## **Technical Service Information**

## THM 4L60 (700-R4) REVISED ACCUMULATORS FOR SOME 1993 MODELS

## Figure 1

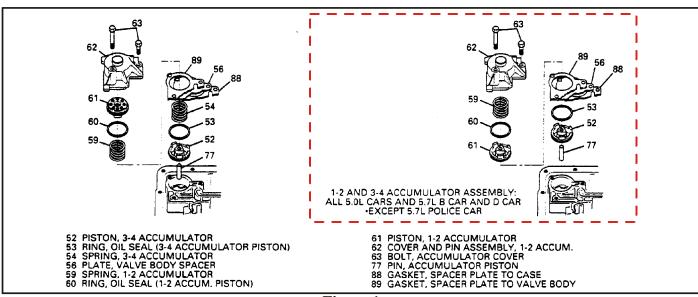
Beginning with the Start of Production for 1993, SOME MODELS of the THM 4L60 (700-R4) transmissions were built with a new calibration that eliminates the 3-4 accumulator spring, and INVERTS the l-2 accumulator piston and spring (See Figure 1),
